BX-8/16 **APR. 1988**

SERVICE NOTES First Edition

Change PHONES ground

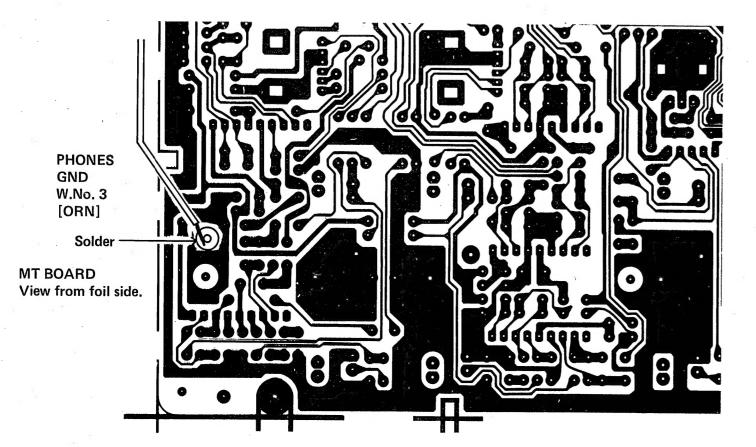
CAUTION: This modification is mandatory . . . Must be conducted on all products as retrofit.

EFF : BX-8 881800-UP

: BX-16 881500-UP

Change soldering point of phones return path.

Reason: Eliminate crosstalk.

PHONESグランドライン・ワイヤリング取り付け箇所変更

変更箇所:下図参照
